## TECHNICAL NEWS

**Number:** 98-12-843

### Door mirror casing comes loose

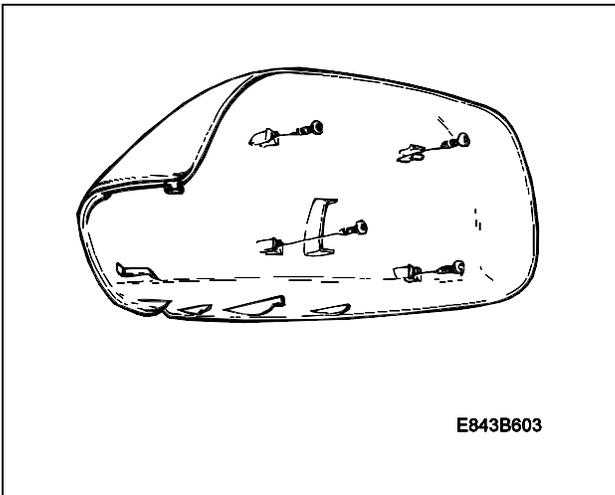
Door mirror casing comes loose.

- 1 Remove the mirror glass.
- 2 Make sure the glass was not damaged during removal.
- 3 Open the three clips just enough to fit the screws (part no. 79 75 535), which will reinforce the casing mounting. See illustration.
- 4 Make sure there are no depressions in the mirror casing. If this is the case, loosen the screws 1-2 turns.
- 5 Make sure the rubber bellows for the mirror motor are in place.
- 6 Fit the glass with the motor in its centre position. The glass must not be loose. Make sure the glass is located correctly.
- 7 Check that the glass can be adjusted to all end positions.
